# ADDENDUM No. 1

RFP No. 24-08

## S Seventh St. & Greenview Dr. Improvements

SCALE: 1" = 40'  
DRAWING No. 2020031-16  
SHEET No.

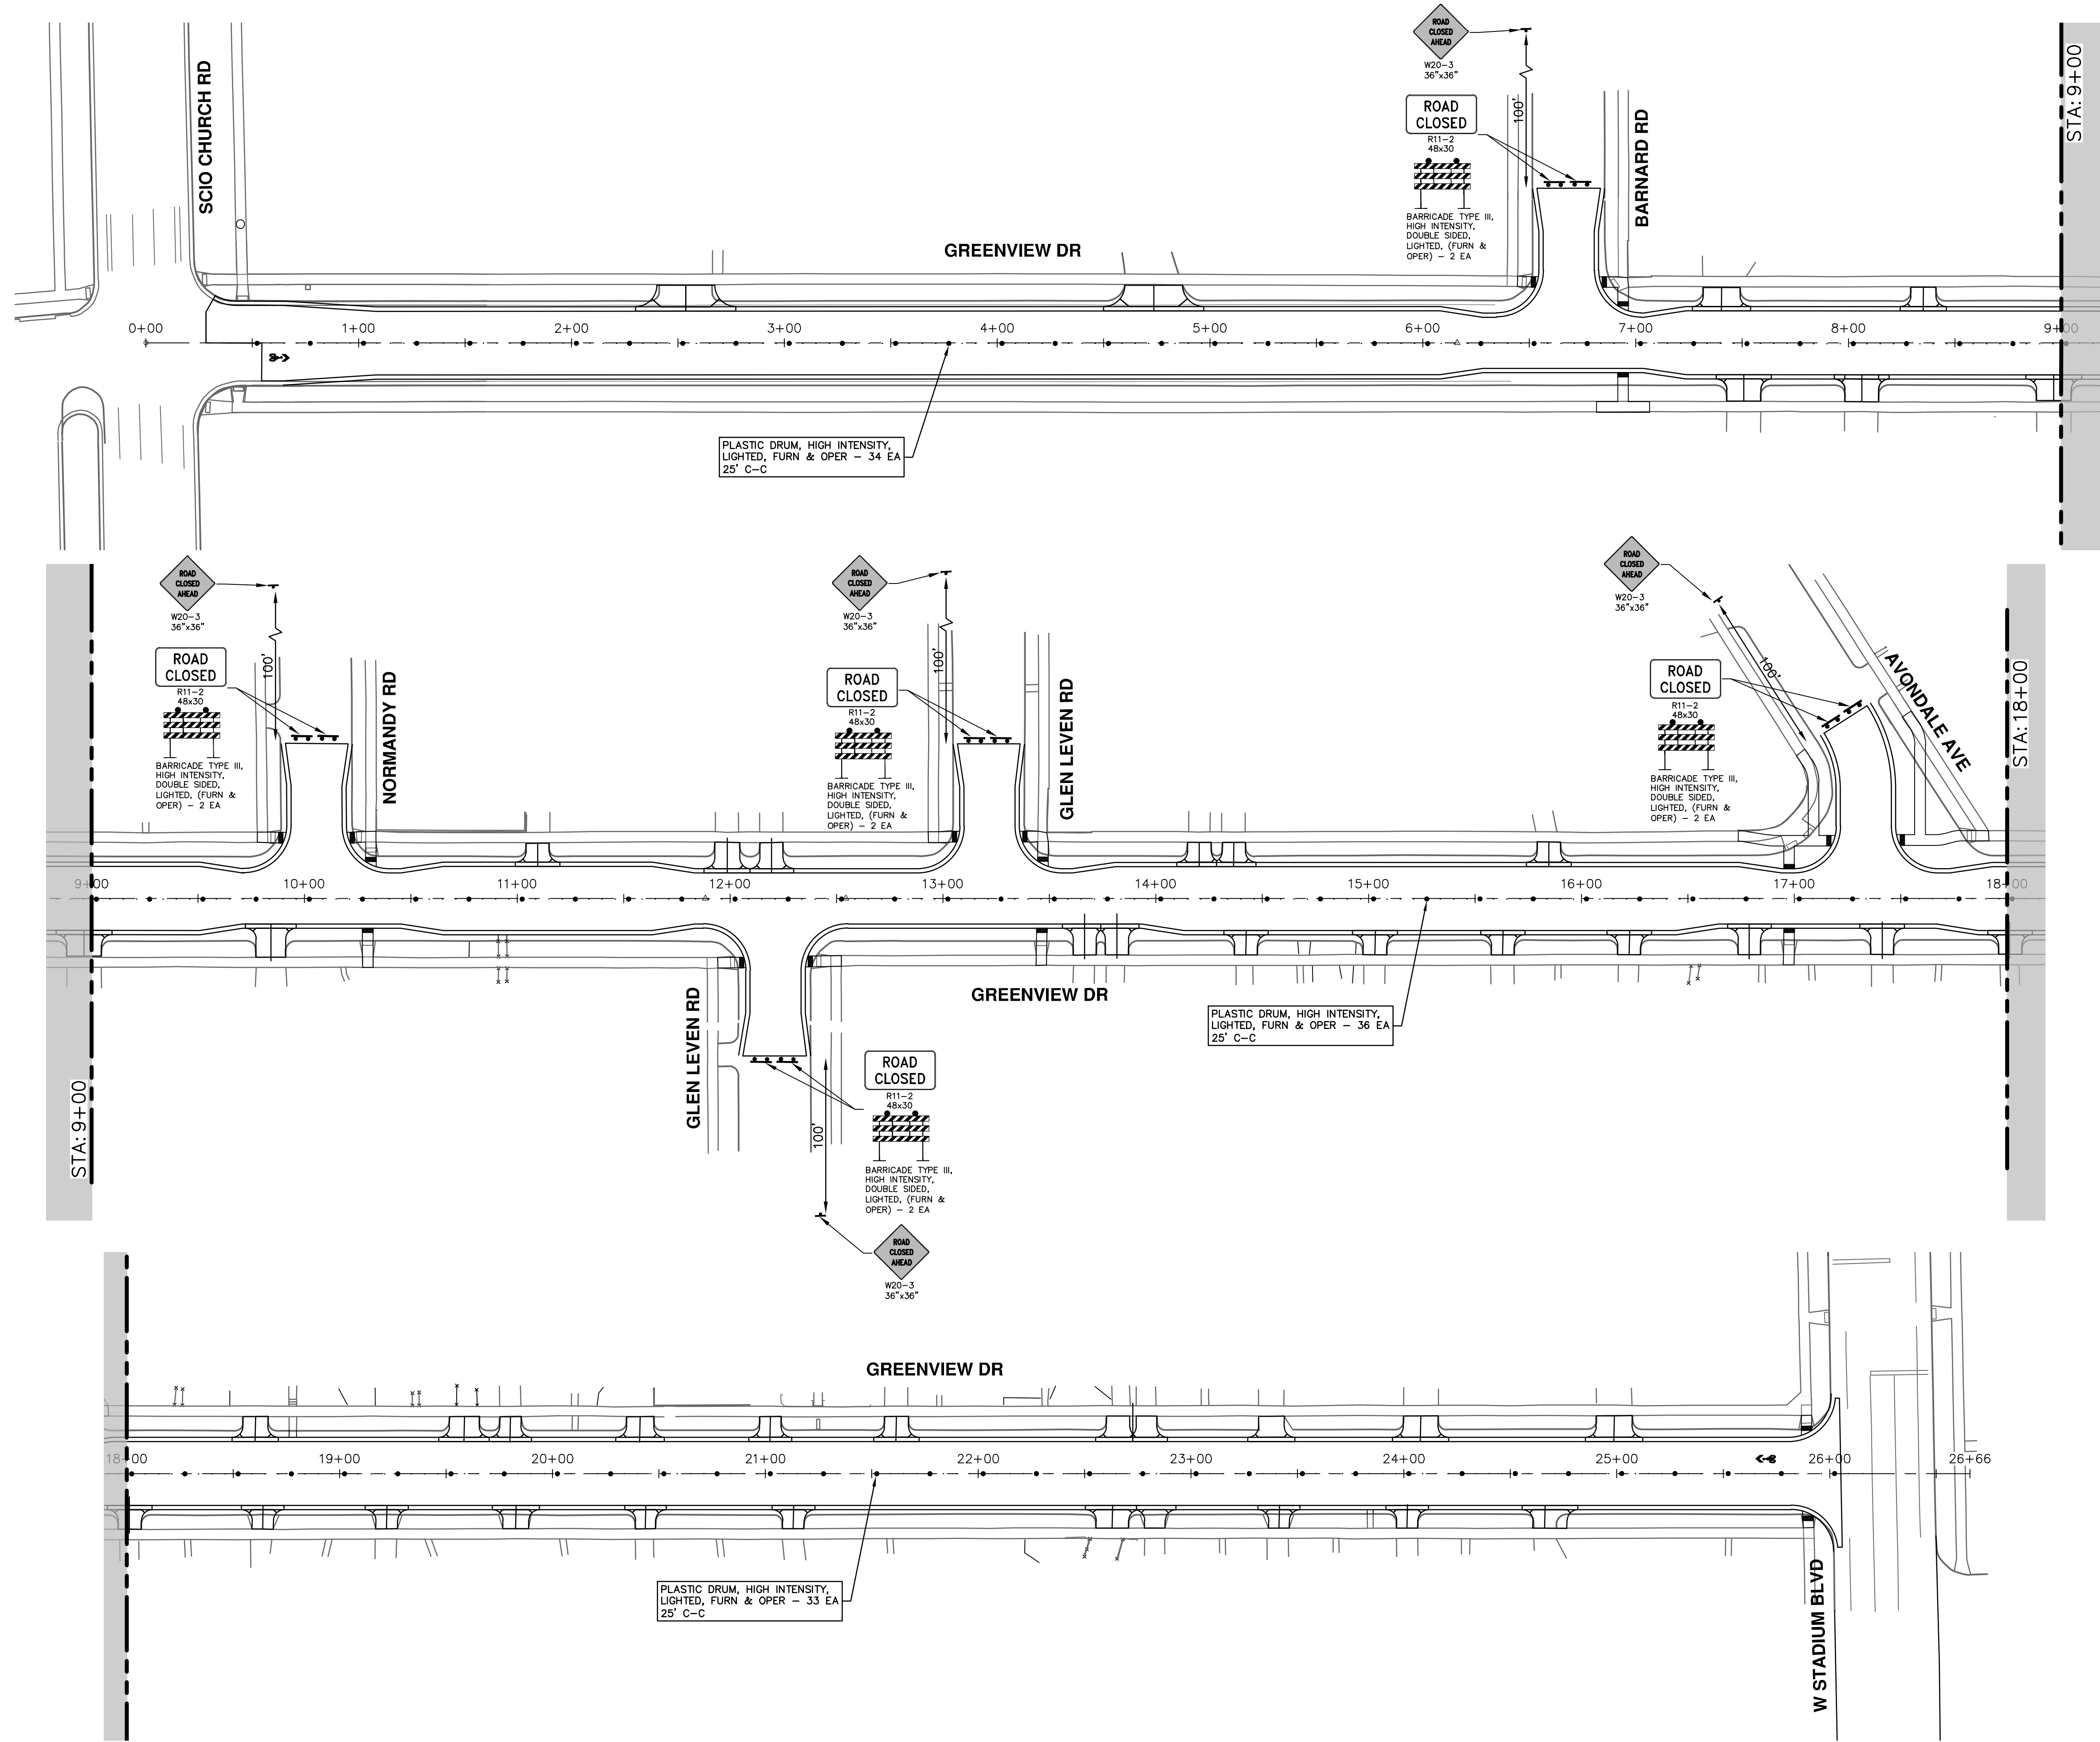
Sheet 16: Remove sheet

SCALE PLAN: 1" = 20'  
 PROFILE: 1" = 2'  
 SHEET No. 28 OF 92  
 DRAWING No. 2020031-28

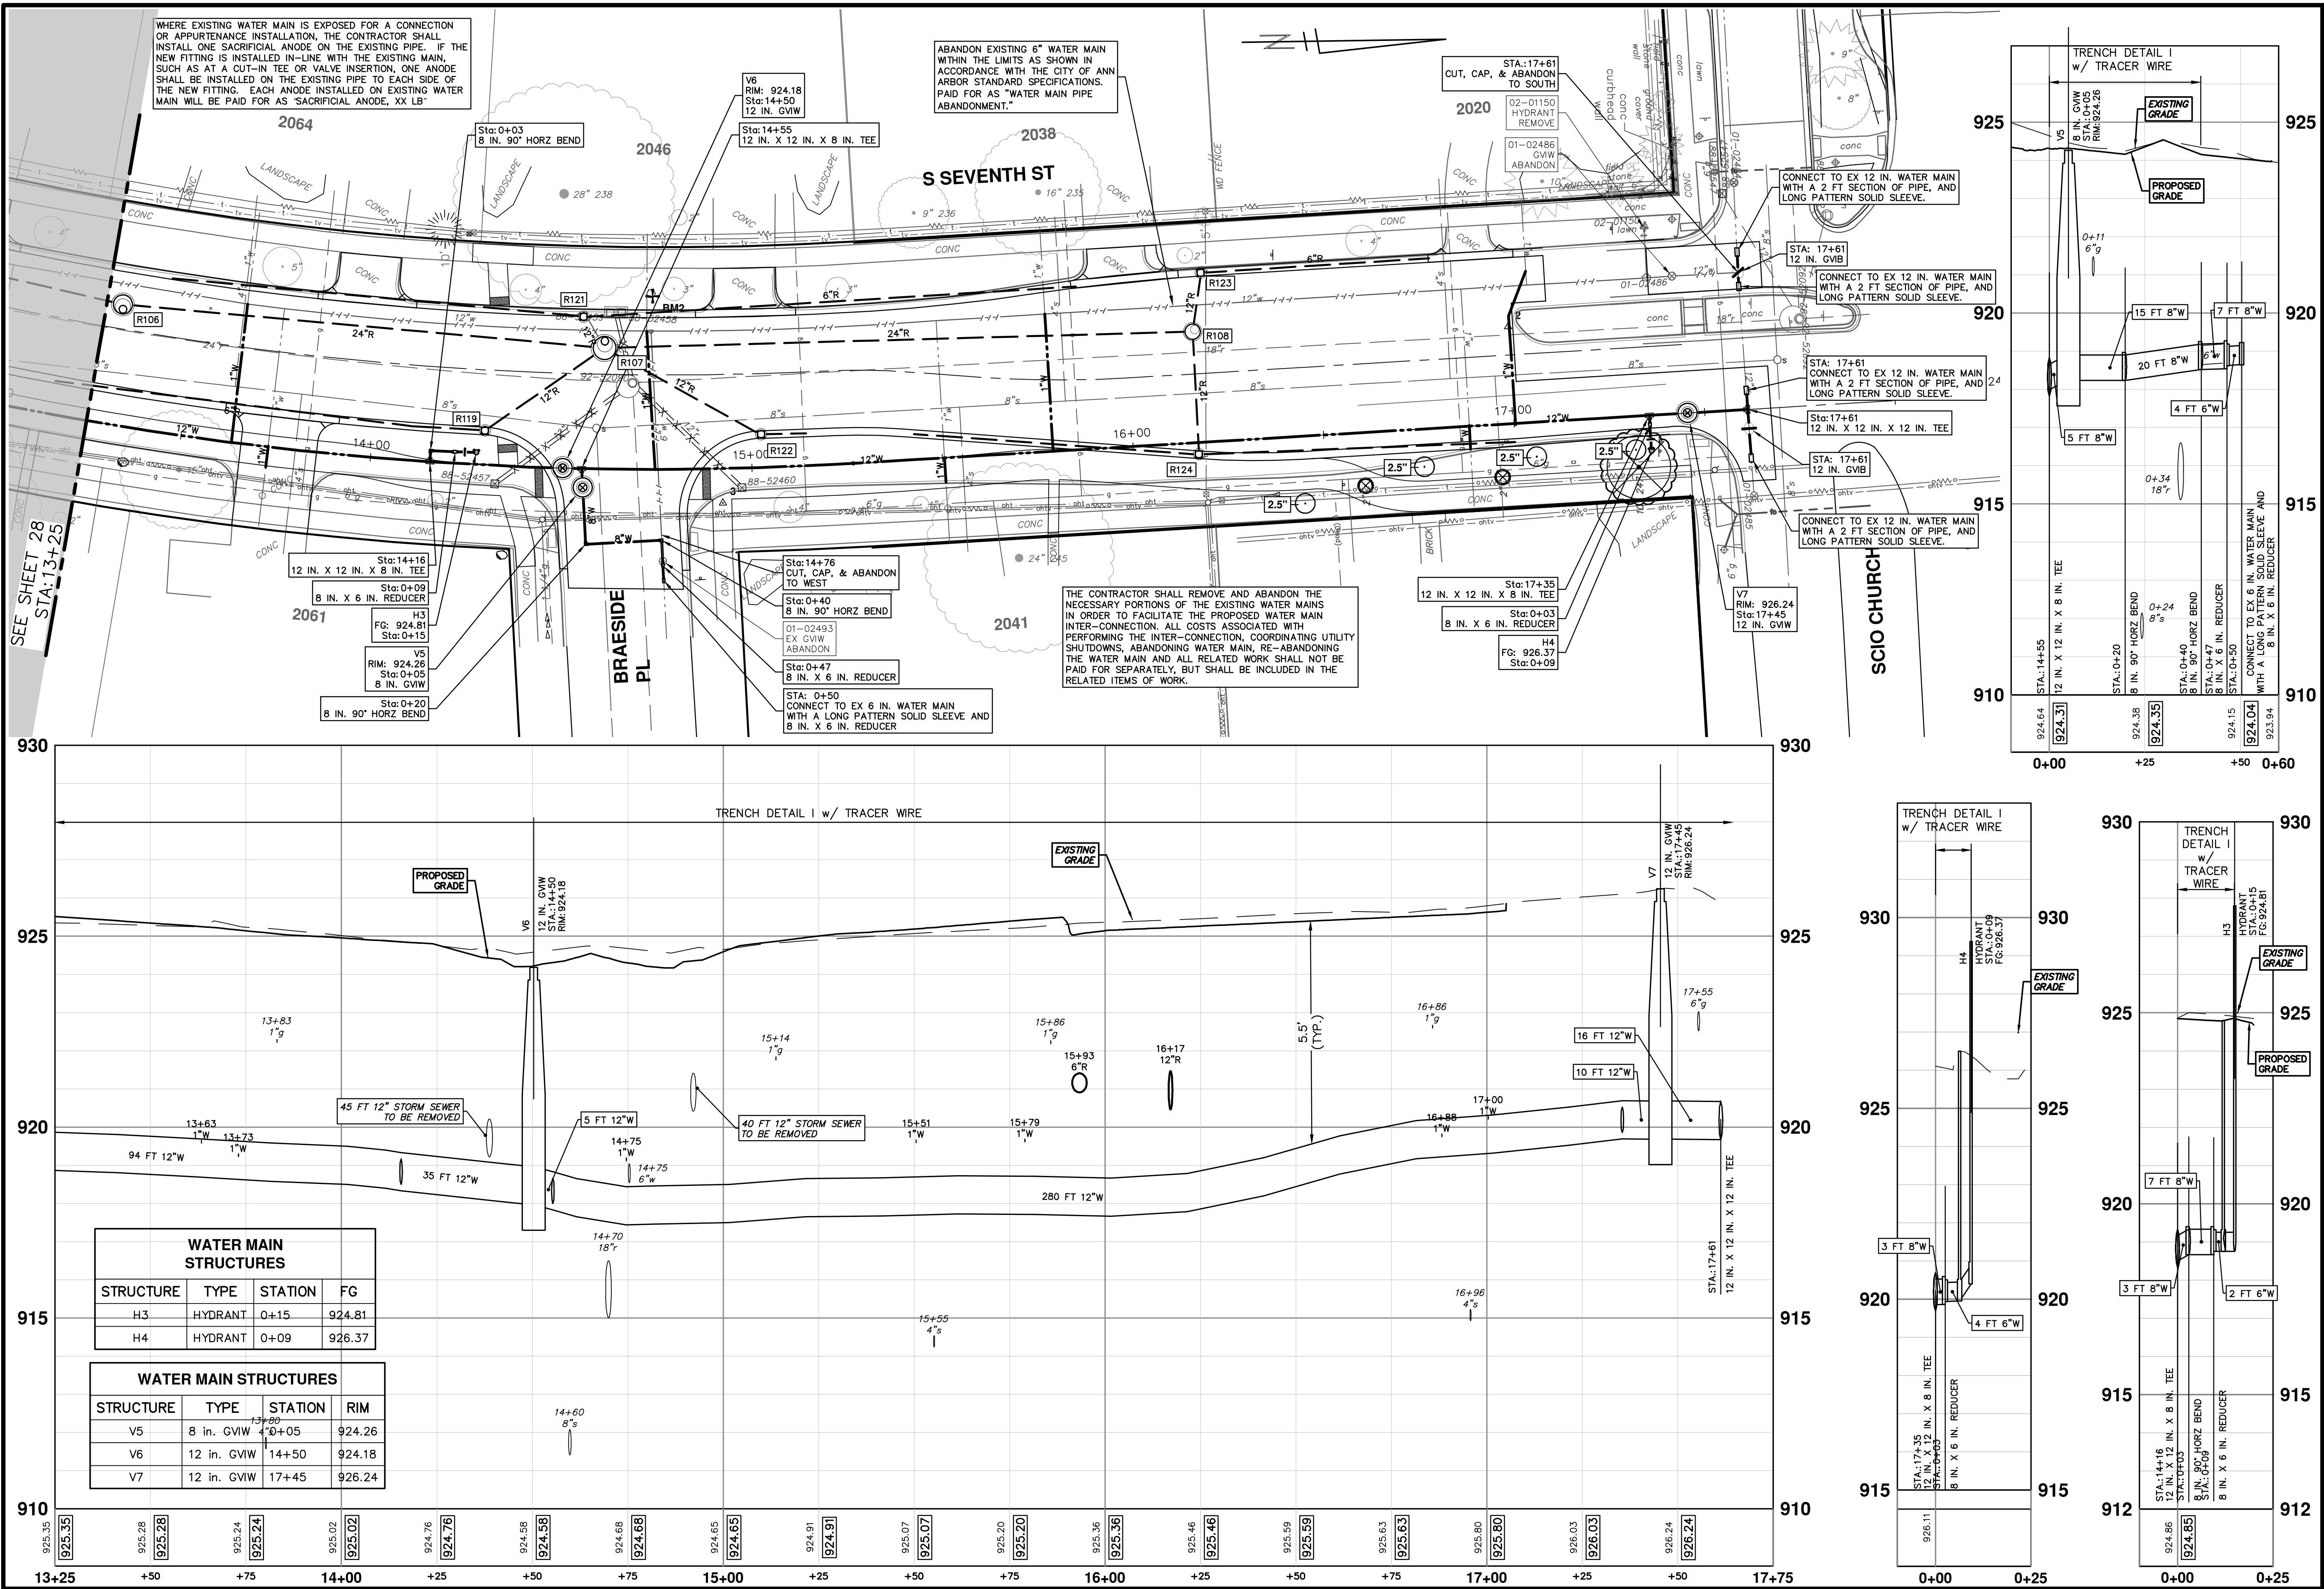
Question 12: How are the water main connections that show new water main in the same location as existing water main (example Lans Way intersection on sheet 28) supposed to be completed and tested?

Answer 12: In areas where the new water main is in the same location as the existing water main, test as much of the new water main as possible without taking the existing main out of service. Once the new main is ready to be connected, the existing main will be shut down and removed. The new main will be swabbed and connected and the existing main will be put back in service, ideally within one day.

SCALE PLAN: 1" = 20'  
PROFILE: 1" = 2'  
DRAWING No. 2020031-55  
SHEET No. 55 OF 92

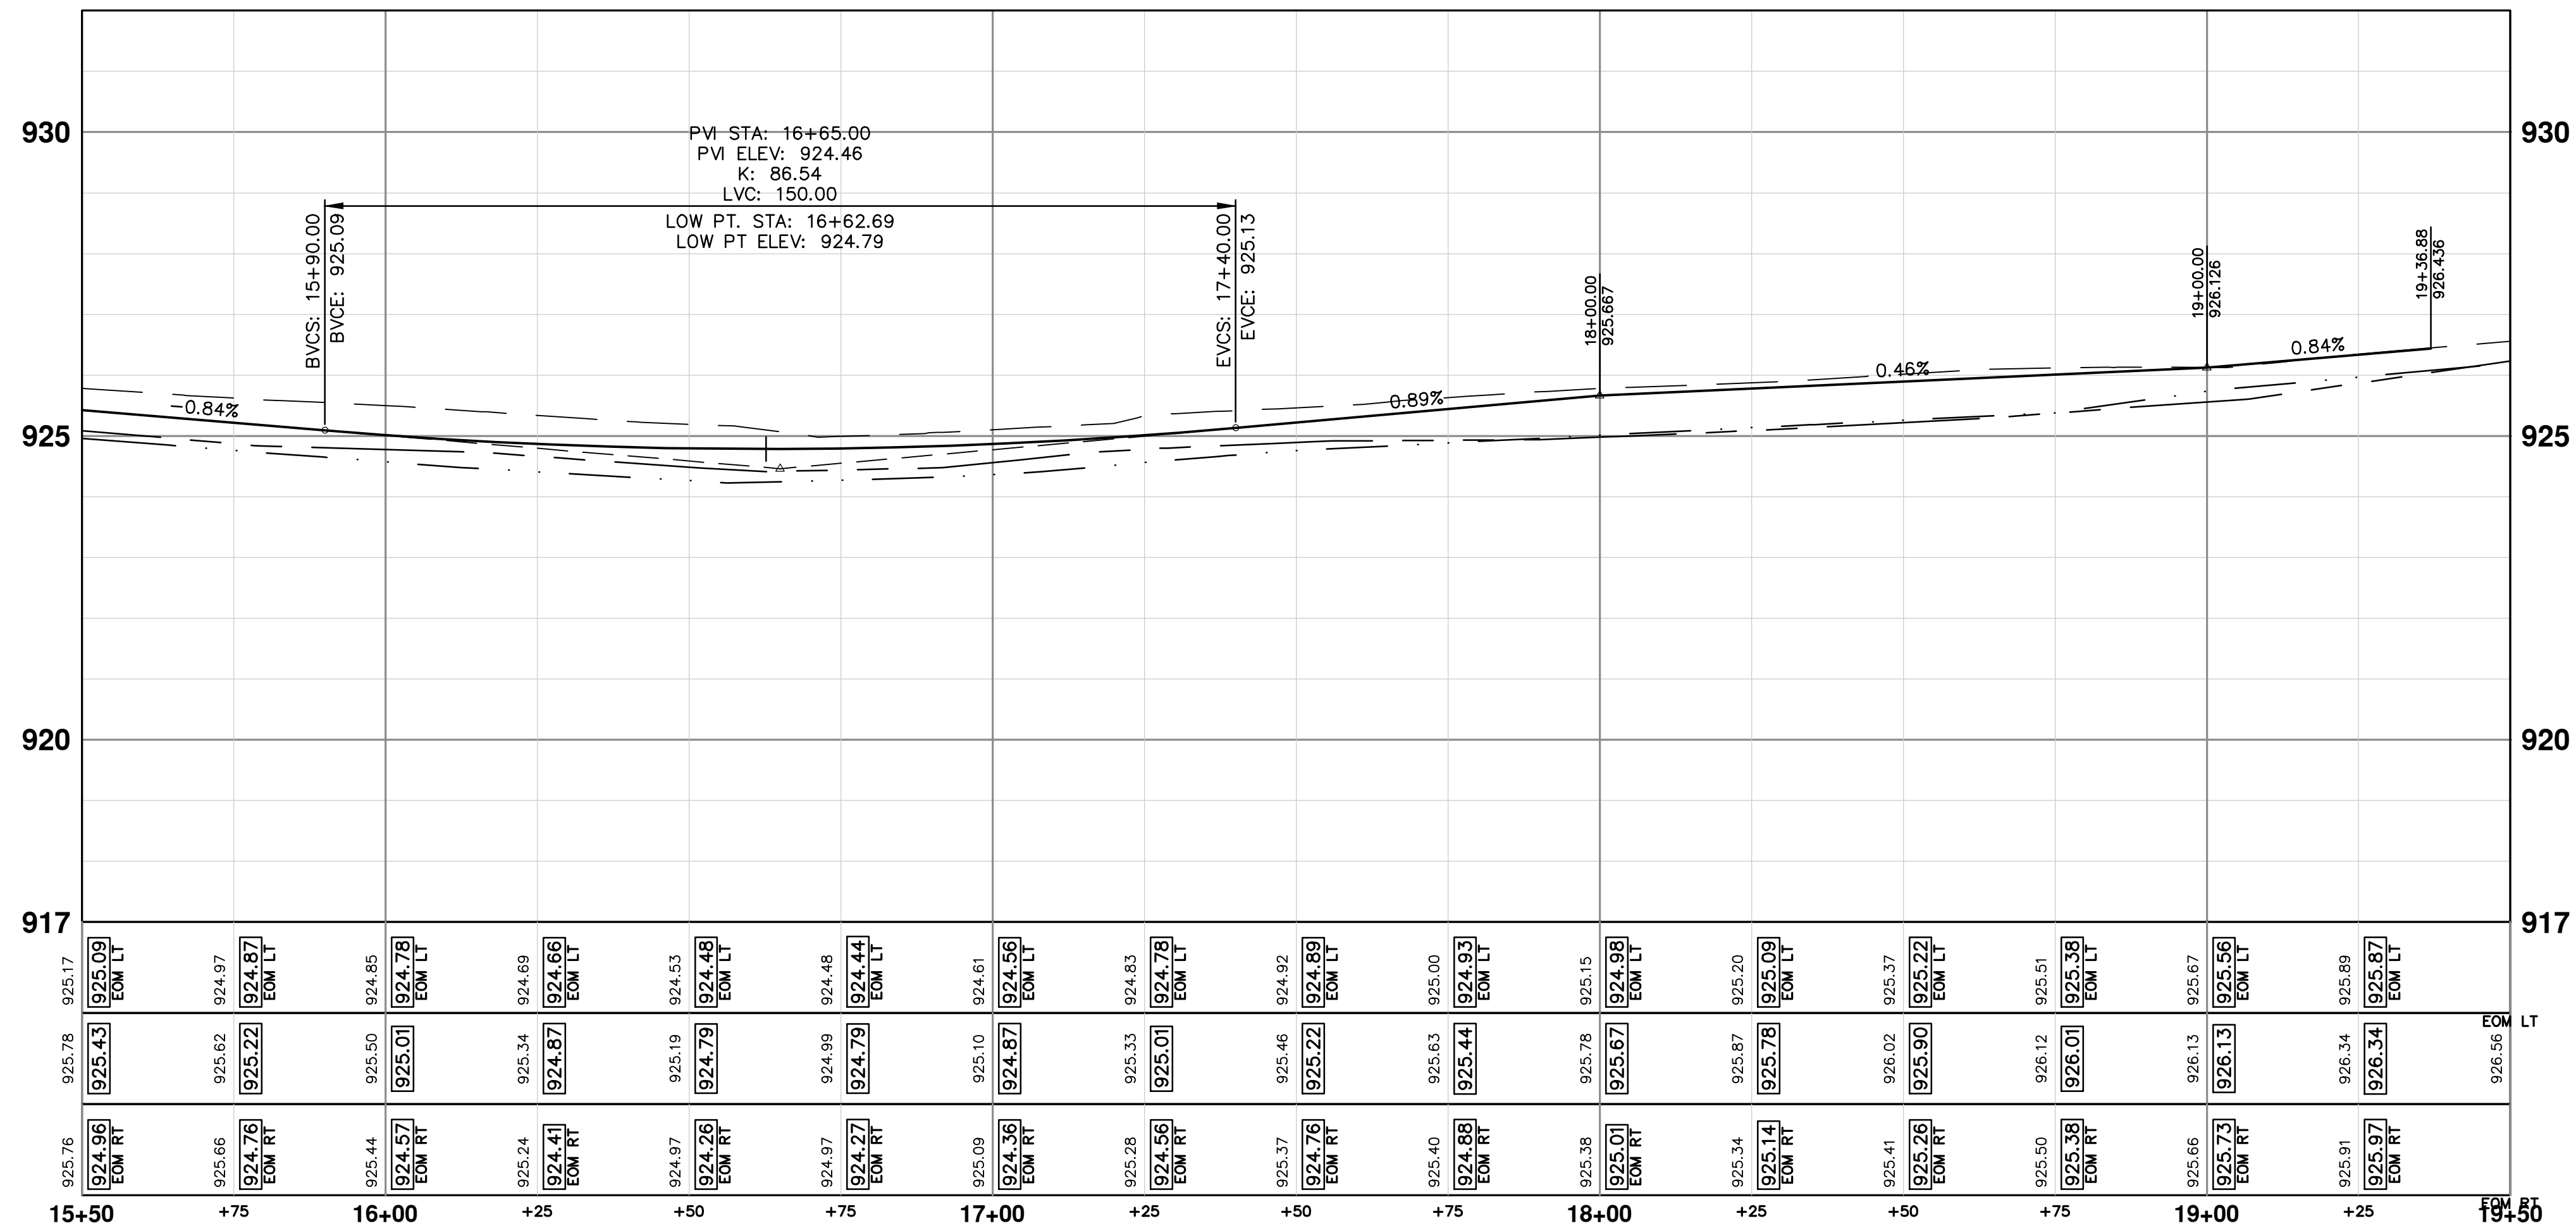
Sheet 55: Sidewalk alignment changed
